MASTER DEVELOPMENT PLAN (MDP) NO: #045-06

MARBACH VILLAGE SUBDIVISION
SAN ANTONIO, TEXAS

MASTER DEVELOPMENT PLAN

Re: **Marbach Village Subdivision**

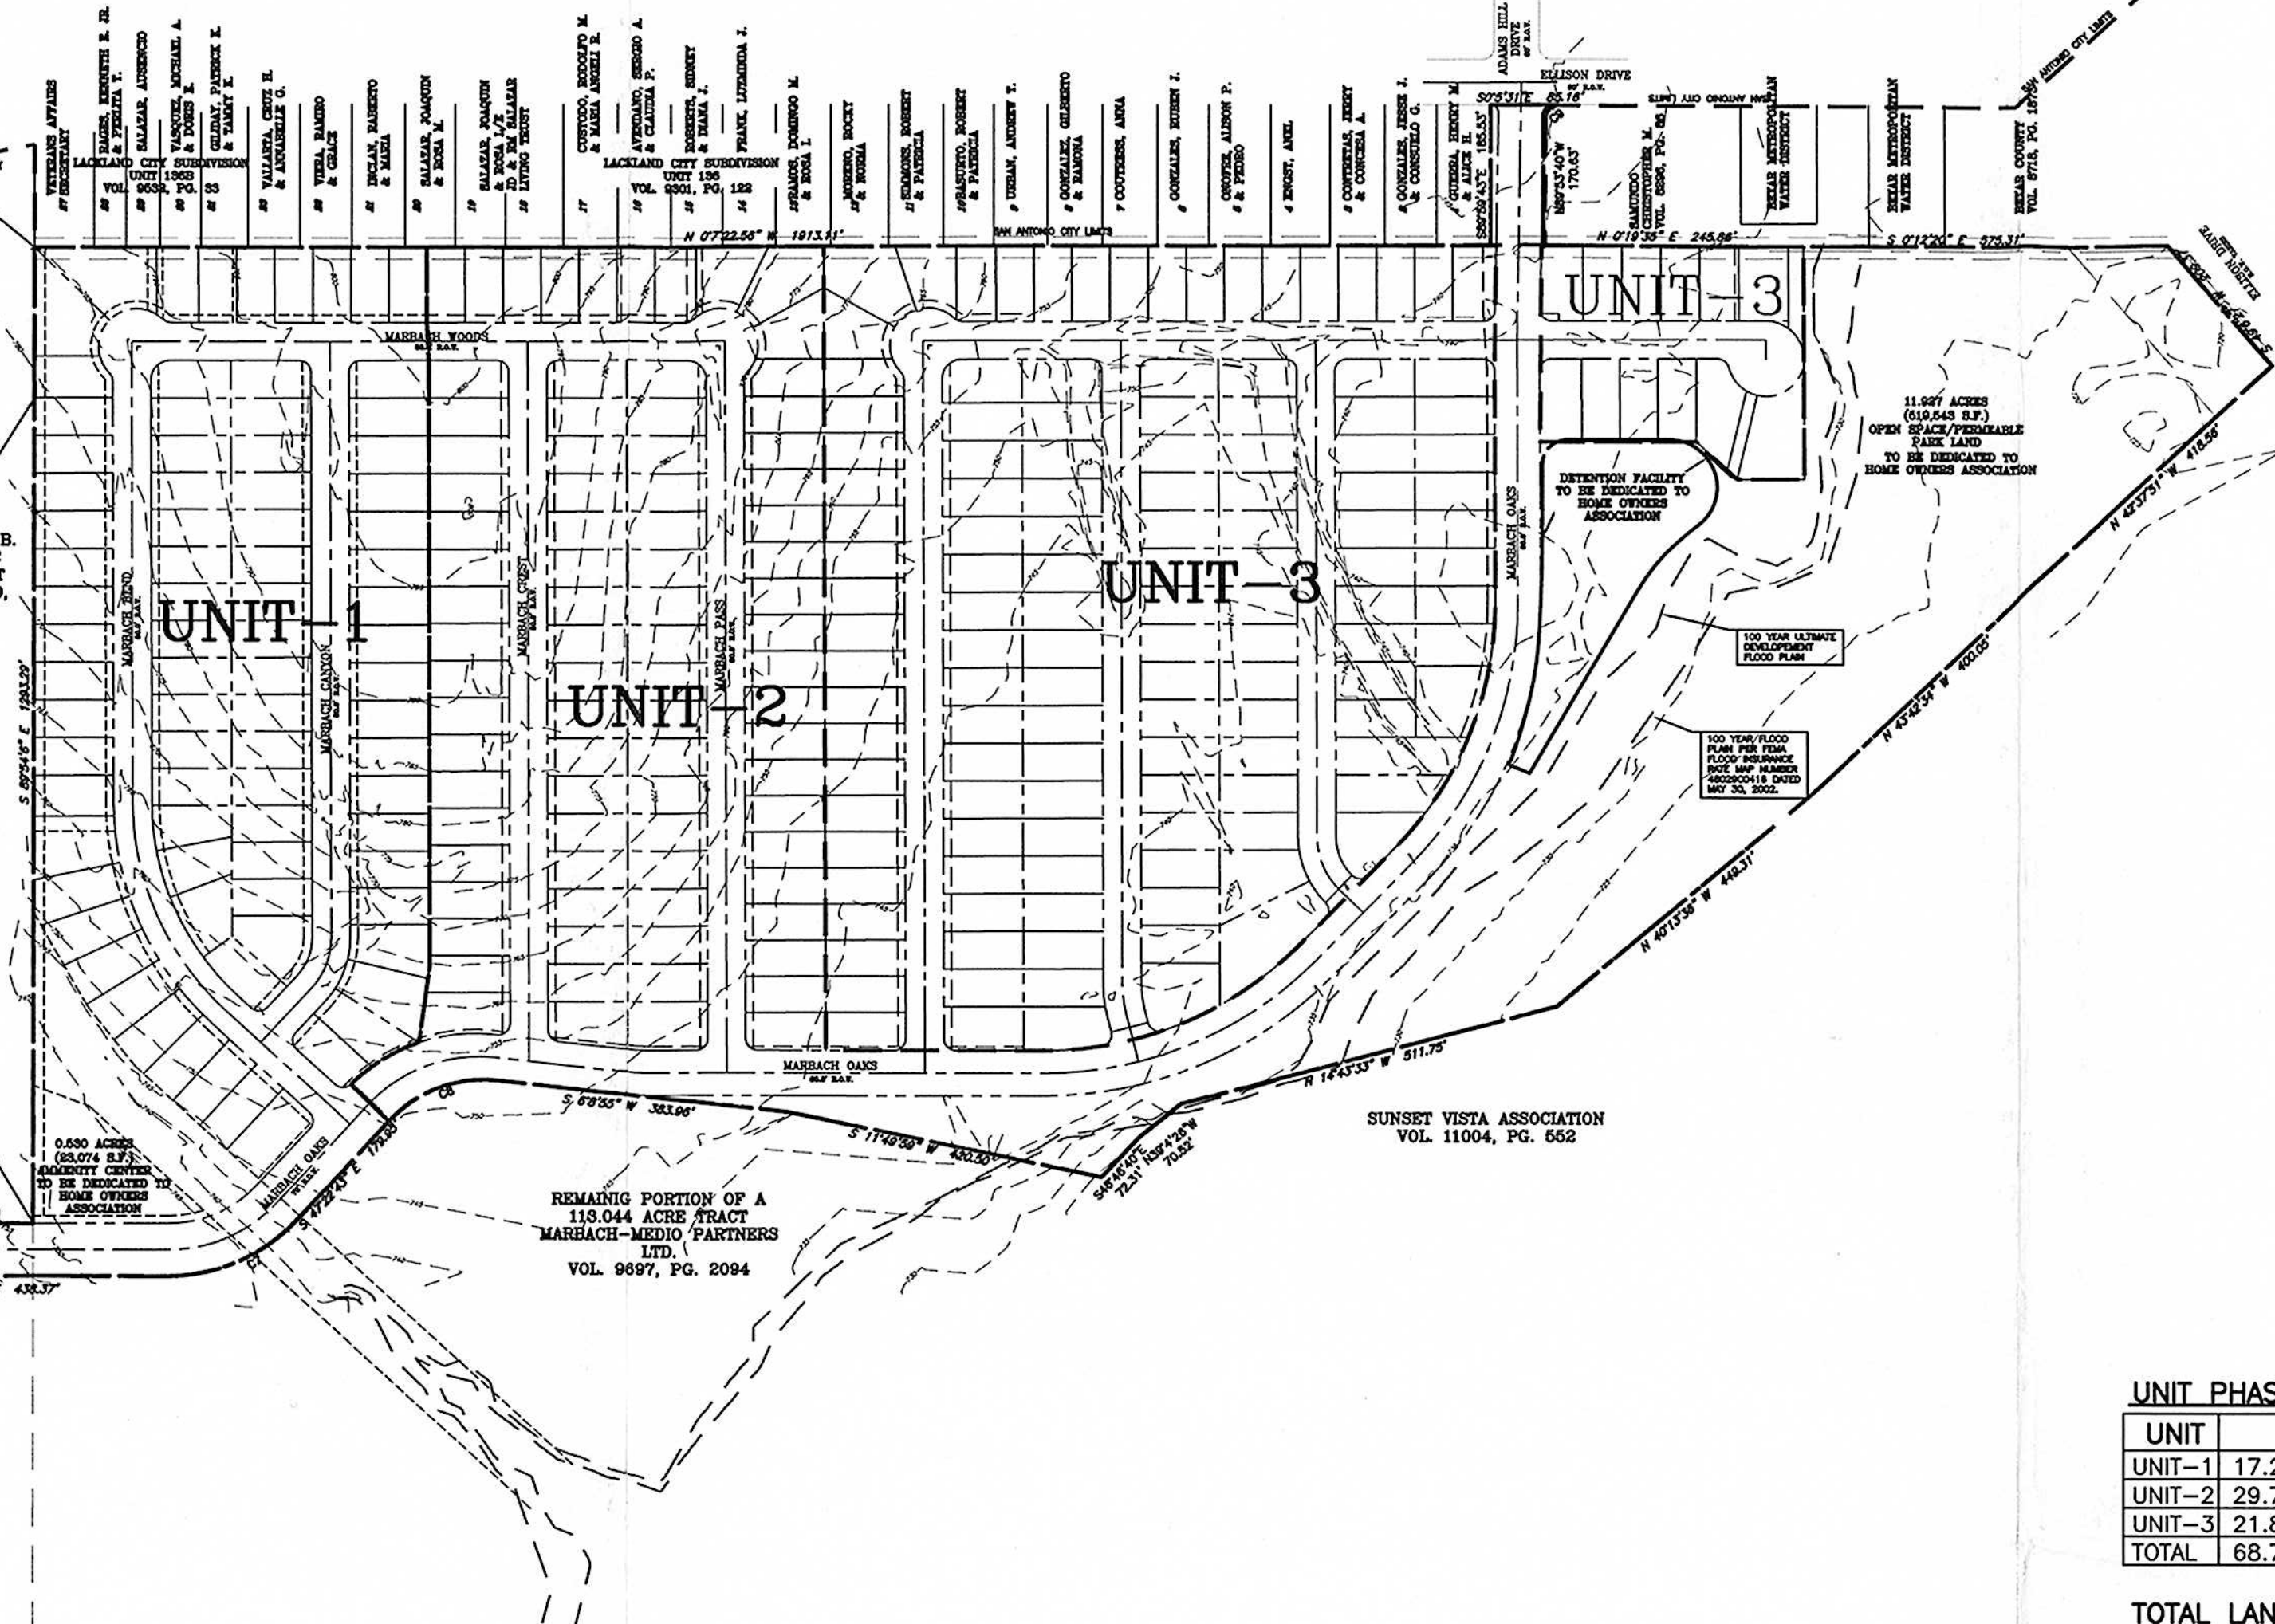
In consideration of public safety and convenience, excessive grades by reason of topography should be avoided in street layouts and arrangements. Any access and R.O.W. issues along state facilities will need to be resolved with the **Texas Department of Transportation (TXDOT)**. For information about these requirements you can contact TXDOT at 615-5814.

- A right / deceleration lane will be required at Marbach Rd. and Marbach Oaks.

- 2003 Tree Preservation ordinance standards per UDC Section 35-523 –a Master Tree Permit (AP 1298245) is pending approval for entire MDP area. Additional \$75 fee will be required for future platting of units.
- Streetscape standards per UDC Section 35-512 - The new ROW on Marbach Oaks will require streetscaping.

Parks and Recreation Department: Marbach Village is a proposed subdivision with 303 single-family residential units. UDC Section 35-503, Table 503-1 states that single-family development is required to provide 1 acre of park/open space per every 70 dwelling units. The requirement for this development is 4.3 acres. This subdivision provides 8.6 acres inside the 100-year flood plain for a credit of 2.15 acres of open space dedication, plus 3.3 acres outside the floodplain. Also, 0.9 acres credit is awarded for two pools totaling 1,040 square feet of water surface area. The total amount of parkland dedication for this project is 6.1 acres.

- The parkland provided shall be shown as “Park” or “Open Space” on a plat; UDC sections 35-503(e) *Designation of Parkland*.
- The parkland provided shall be dedicated to the Home Owners Association.
- The instruments creating the Home Owners Association shall be provided by the second application for plat approval; UDC sections 35-503(e) *Designation of Parkland*.
- Parkland dedication shall be platted by the second phase of residential development; UDC section 35-503(f) *Development Phasing*.
- All amenities provided shall comply with standards and specifications found in UDC section 35-503(h) *Credit for Park Facilities* and Table 503-4 if any credit is to be awarded.
